CITY OF ARLINGTON, TEXAS

2013 Sidewalk Program
Project No. PWSW13001
Location Overview Map

City of Arlington: Survey List 2

Report No. ECPRW-7209

Matlock & Valley Spring Ramps
Valley Spring & Caprock Ramps

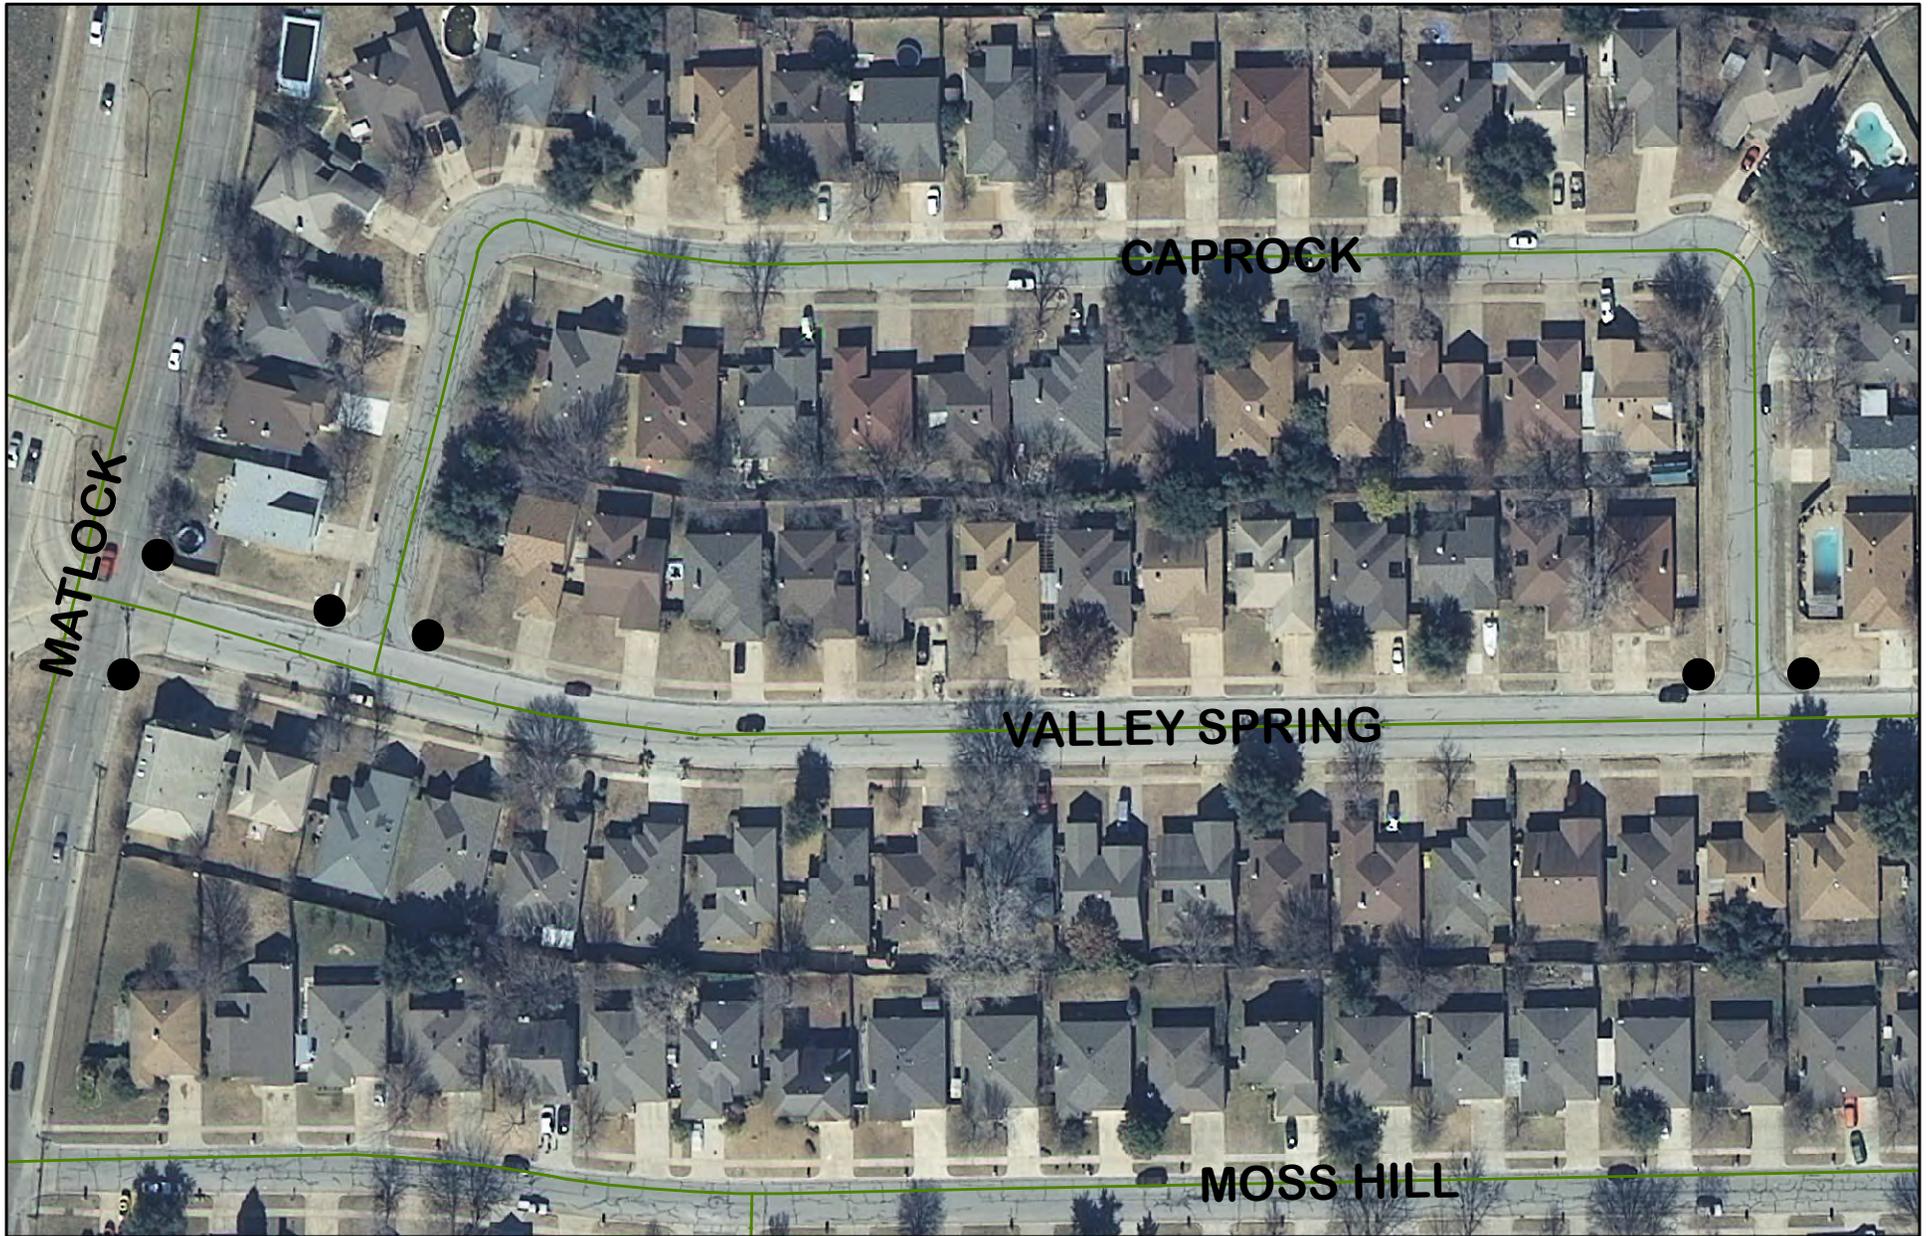
Line	Road System	Segment	From	To	Side	Item No.	Issue	ADA Code	Proposed Correction	P. Level	Photo	City Category	City Notes
						0829	Transition from ramp to gutter has a 27.7 % non-compliant running slope.	§4.7	Rework curb ramp to provide a running slope not to exceed 8.33% (ADAAG Fig. 11).	1A	B513	B	Same note.
						0830	SE curb ramp type 1, surface does not have truncated domes or contrasting color.	§4.29	Rework surface to provide raised truncated domes with a diameter of nominal 0.9" (22 mm), a height of 0.2" (5 mm) and a center-to-center spacing of nominal 2.35" (59 mm) and that shall contrast visually with adjoining surfaces.	1A	B515	B	Same note.
						0831	The surface of the sidewalk is unstable and has loose material.	§4.5	Rework and clean sidewalk to provide a stable, firm, and slip-resistant floor surface.	1B	B515	B	Same note.
						0832	Curb ramp has a 13.6 % non-compliant running slope.	§4.7	Rework curb ramp to provide a running slope not to exceed 8.33% (ADAAG Fig. 11).	1A	B515	B	Same note.

0833	Accessible route has a non-compliant cross slope of 15.3 %.	§4.3	Rework or repave accessible route to provide a cross slope not exceeding 2%.	1A	B515	B	Same note.
						0834	Transition from ramp to gutter has a 29.3 % non-compliant running slope.	§4.7	Rework curb ramp to provide a running slope not to exceed 8.33% (ADAAG Fig. 11).	1A	B515	B	Same note.
						0835	Accessible route has a non-compliant cross slope of 8.0 % that extends 55 ft (16.76 m).	§4.3	Rework or repave accessible route to provide a cross slope not exceeding 2%.	1A	B515	B	Same note.
0148	City	Intersection of Valley Spring Dr. and Caprock Dr.	N/A	N/A	North	*0836	NW curb ramp type 3, surface does not have truncated domes or contrasting color.	§4.29	Rework surface to provide raised truncated domes with a diameter of nominal 0.9" (22 mm), a height of 0.2" (5 mm) and a center-to-center spacing of nominal 2.35" (59 mm) and that shall contrast visually with adjoining surfaces.	1A	B517, B518	B	Altered with major street maintenance in 2000/2001; will reconstruct ramps at all corners of intersection within compliance period (NW ramp usability acceptable); see photos 9, 10, 11, 12

0837	Curb ramp has a 14.4 % non-compliant running slope.	§4.7	Rework curb ramp to provide a running slope not to exceed 8.33% (ADAAG Fig. 11).	1A	B517	B	Same note.
						0838	NE curb ramp type 3, surface does not have truncated domes or contrasting color.	§4.29	Rework surface to provide raised truncated domes with a diameter of nominal 0.9" (22 mm), a height of 0.2" (5 mm) and a center-to-center spacing of nominal 2.35" (59 mm) and that shall contrast visually with adjoining surfaces.	1A	B519	B	Same note.
						0839	The surface of the sidewalk is unstable and has loose material.	§4.5	Rework and clean sidewalk to provide a stable, firm, and slip-resistant floor surface.	1B	B519	B	Same note.
						0840	Curb ramp has a 14.1 % non-compliant running slope.	§4.7	Rework curb ramp to provide a running slope not to exceed 8.33% (ADAAG Fig. 11).	1A	B519	B	Same note.
						0841	Accessible route has a non-compliant cross slope of 3.0 %.	§4.3	Rework or repave accessible route to provide a cross slope not exceeding 2%.	1A	B519	B	Same note.

Valley Spring & Pinehill Ramps

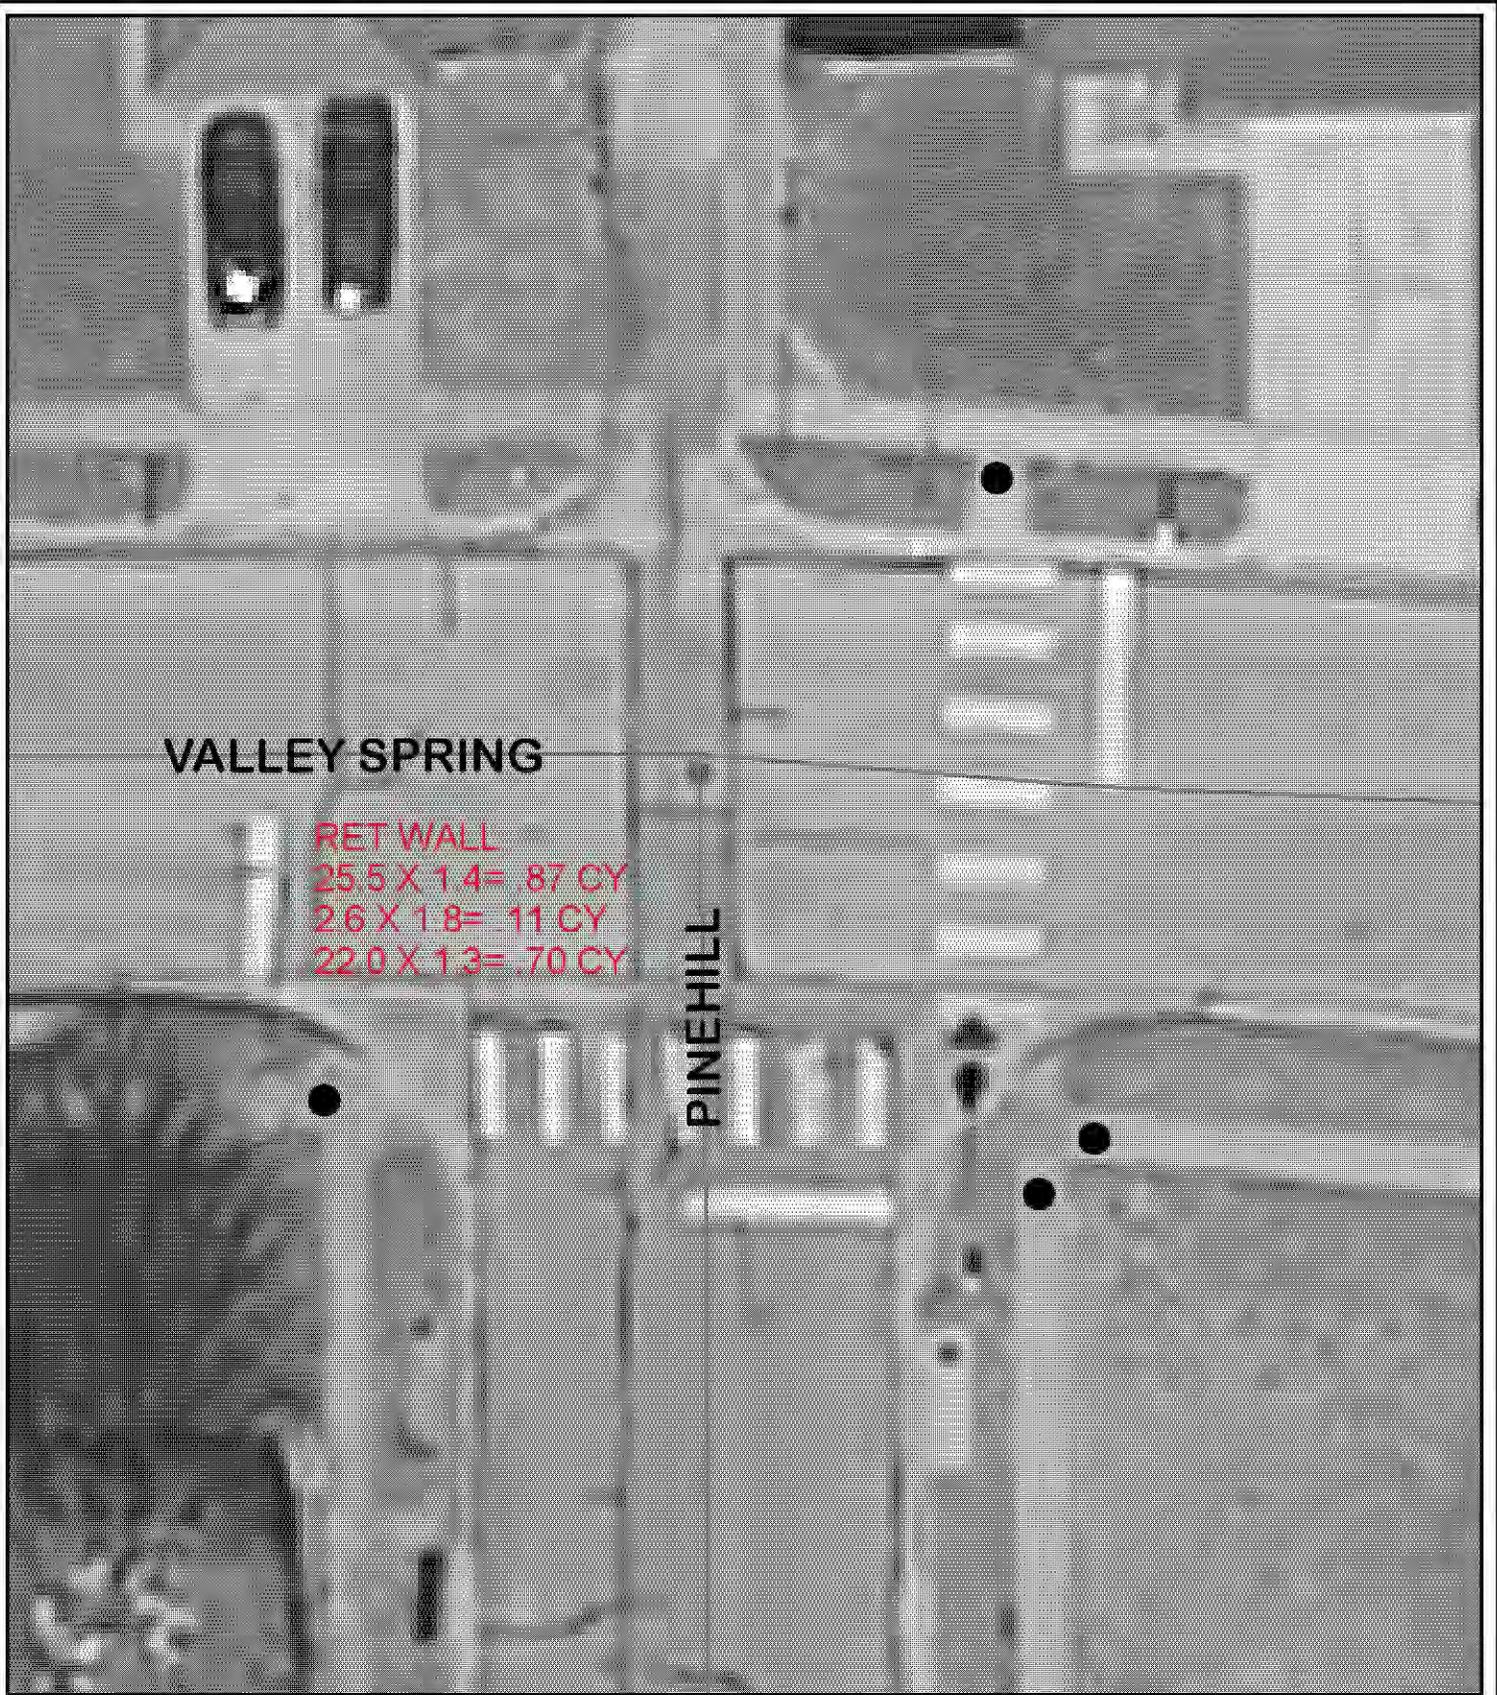
Line	Road System	Segment	From	To	Side	Item No.	Issue	ADA Code	Proposed Correction	P. Level	Photo	City Category	City Notes
0150	City	Intersection of Valley Spring Dr. and Pinehill Dr.	N/A	N/A	South	0849	SE curb ramp type 3, surface does not have truncated domes or contrasting color.	§4.29	Rework surface to provide raised truncated domes with a diameter of nominal 0.9" (22 mm), a height of 0.2" (5 mm) and a center-to-center spacing of nominal 2.35" (59 mm) and that shall contrast visually with adjoining surfaces.	1A	B526	B	Altered with major street maintenance in 2000/2001; propose to reconstruct ramps within compliance period (SE ramp usability acceptable); see photos 5, 6
						0850	Curb ramp has a 13.5 % non-compliant running slope.	§4.7	Rework curb ramp to provide a running slope not to exceed 8.33% (ADAAG Fig. 11).	1A	B526	B	Same note.
						0851	SE curb ramp type 3, surface does not have truncated domes or contrasting color.	§4.29	Rework surface to provide raised truncated domes with a diameter of nominal 0.9" (22 mm), a height of 0.2" (5 mm) and a center-to-center spacing of nominal 2.35" (59 mm) and that shall contrast visually with adjoining surfaces.	1A	B527	B	Same note.

0852	Curb ramp has a 8.9 % non-compliant running slope.	§4.7	Rework curb ramp to provide a running slope not to exceed 8.33% (ADAAG Fig. 11).	1A	B527	B	Same note.
0157	City	Intersection of Pleasant Ridge and Woodside Dr.	N/A	N/A	West	0879	SW curb ramp type3, surface does not have truncated domes or contrasting color.	§4.29	Rework surface to provide raised truncated domes with a diameter of nominal 0.9" (22 mm), a height of 0.2" (5 mm) and a center-to-center spacing of nominal 2.35" (59 mm) and that shall contrast visually with adjoining surfaces.	1A	B544	B	NW ramp to be updated by end of 2012; SW corner not altered since 1992 and usability acceptable; see photos 15, 16
						0880	Curb ramp has a 10.6 % non-compliant running slope.	§4.7	Rework curb ramp to provide a running slope not to exceed 8.33% (ADAAG Fig. 11).	1A	B544	B	Same note.
						0881	NW curb ramp type 3, surface does not have truncated domes or contrasting color.	§4.29	Rework surface to provide raised truncated domes with a diameter of nominal 0.9" (22 mm), a height of 0.2" (5 mm) and a center-to-center spacing of nominal 2.35" (59 mm) and that shall contrast visually with adjoining surfaces.	1A	B545	B	Same note.

Pleasant Ridge & Woodside
Ramps

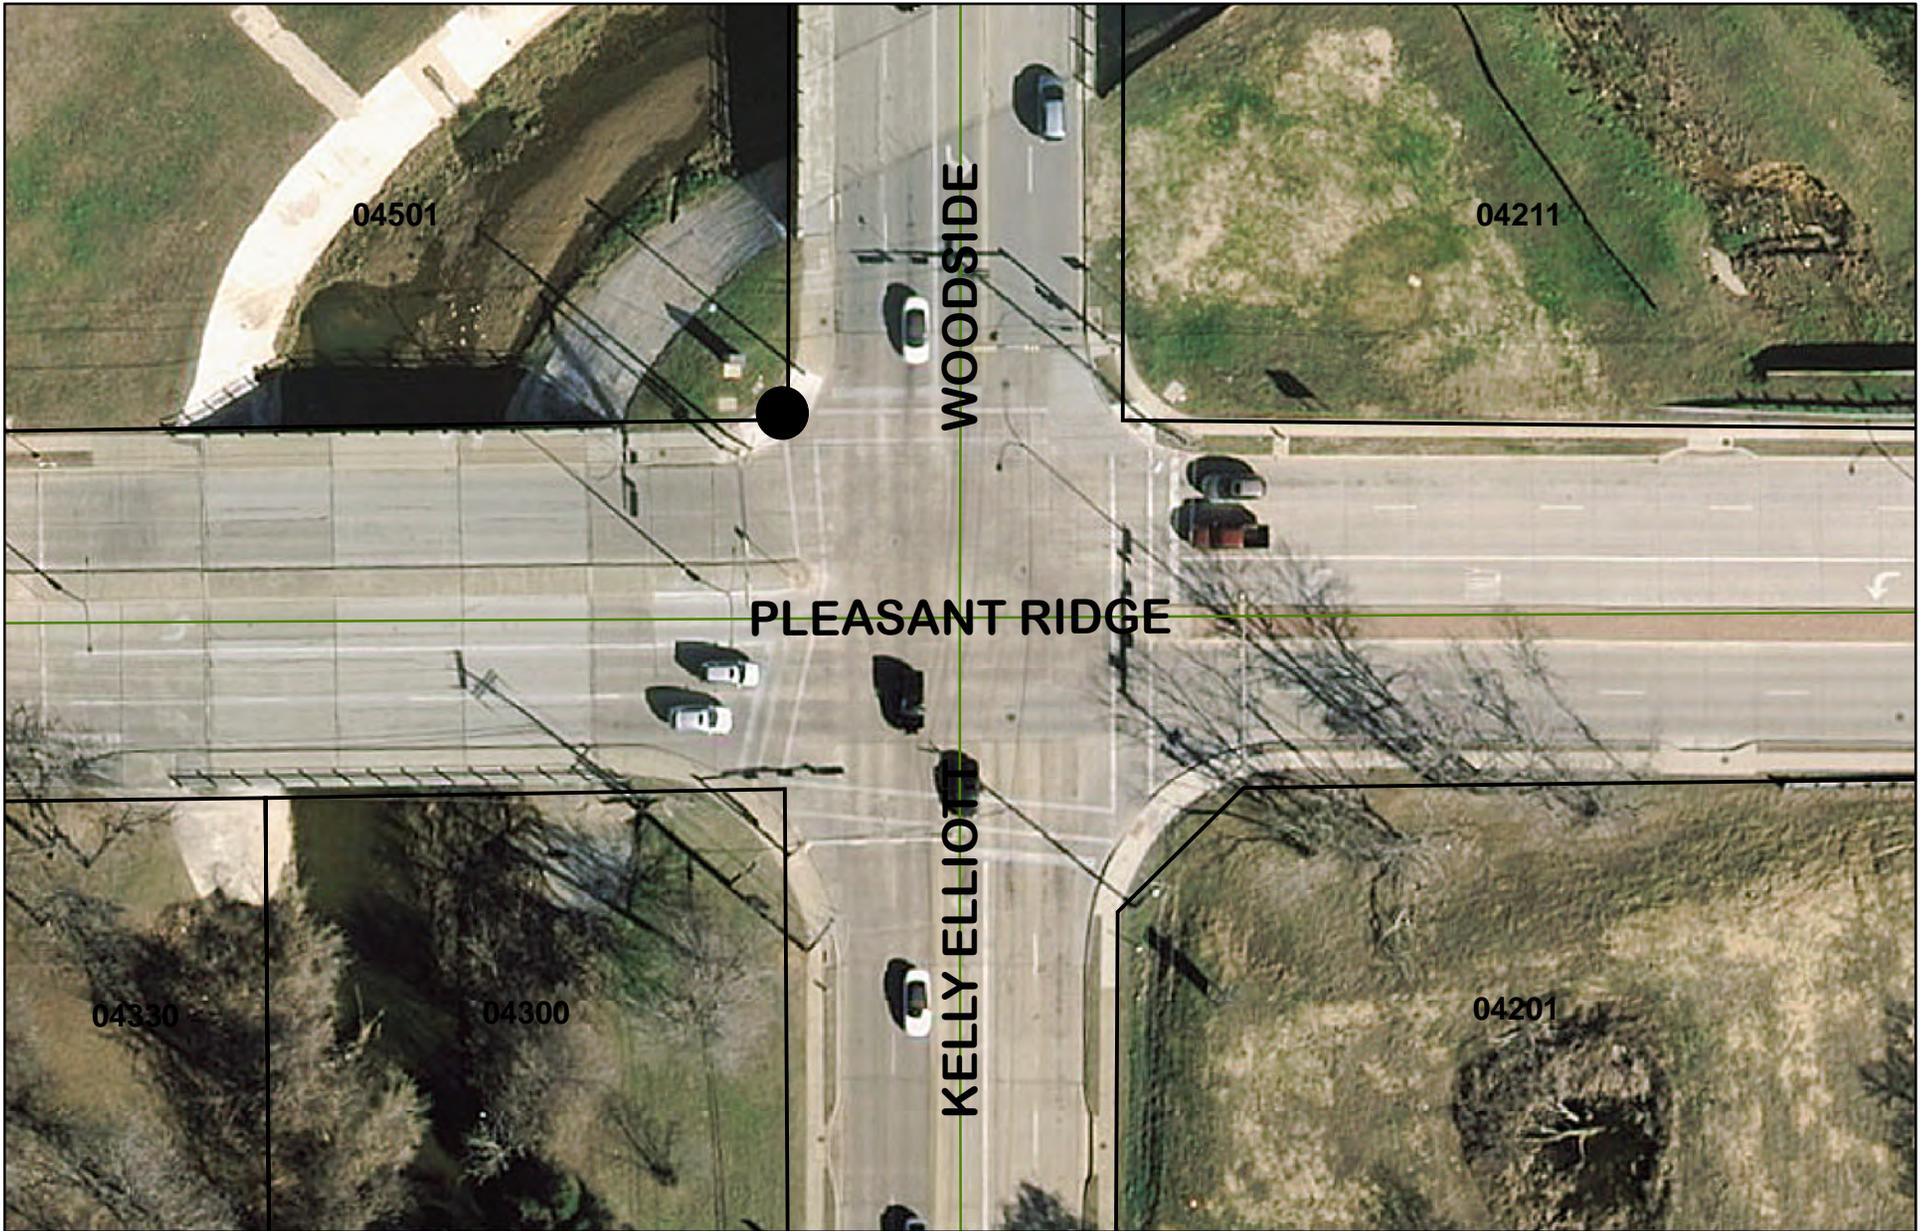
0852	Curb ramp has a 8.9 % non-compliant running slope.	§4.7	Rework curb ramp to provide a running slope not to exceed 8.33% (ADAAG Fig. 11).	1A	B527	B	Same note.
0157	City	Intersection of Pleasant Ridge and Woodside Dr.	N/A	N/A	West	0879	SW curb ramp type3, surface does not have truncated domes or contrasting color.	§4.29	Rework surface to provide raised truncated domes with a diameter of nominal 0.9" (22 mm), a height of 0.2" (5 mm) and a center-to-center spacing of nominal 2.35" (59 mm) and that shall contrast visually with adjoining surfaces.	1A	B544	B	NW ramp to be updated by end of 2012; SW corner not altered since 1992 and usability acceptable; see photos 15, 16
						0880	Curb ramp has a 10.6 % non-compliant running slope.	§4.7	Rework curb ramp to provide a running slope not to exceed 8.33% (ADAAG Fig. 11).	1A	B544	B	Same note.
						0881	NW curb ramp type 3, surface does not have truncated domes or contrasting color.	§4.29	Rework surface to provide raised truncated domes with a diameter of nominal 0.9" (22 mm), a height of 0.2" (5 mm) and a center-to-center spacing of nominal 2.35" (59 mm) and that shall contrast visually with adjoining surfaces.	1A	B545	B	Same note.

0882	Pedestrian cross signal pushbutton does not have clear floor space.	§4.2	Provide a 30" by 48" (762 mm by 1219 mm) min. wheelchair clear floor space (ADAAG #)g.	2C	B546	B	Same note.
		Woodside Drive @ Arkansas					no curb cuts north of Arkansas					B	While there are curb ramps at Woodside/Arkansas, there are no curb cuts on east side of intersection at Woodside/Trowbridge just north of Arkansas. Will add curb ramps at Woodside/Trowbridge by end of 2012
		California/Monties Lane										B	Monties from California to Sunset altered with major maintenance in 2000/2001; will reconstruct ramps within compliance period; see photos 17, 18
		North on West Street										B	West Street between Main and Front altered with Downtown Drg Proj (ST98-04) initiated in 1998; Will update ramp at SE corner West/Abram by end of 2012
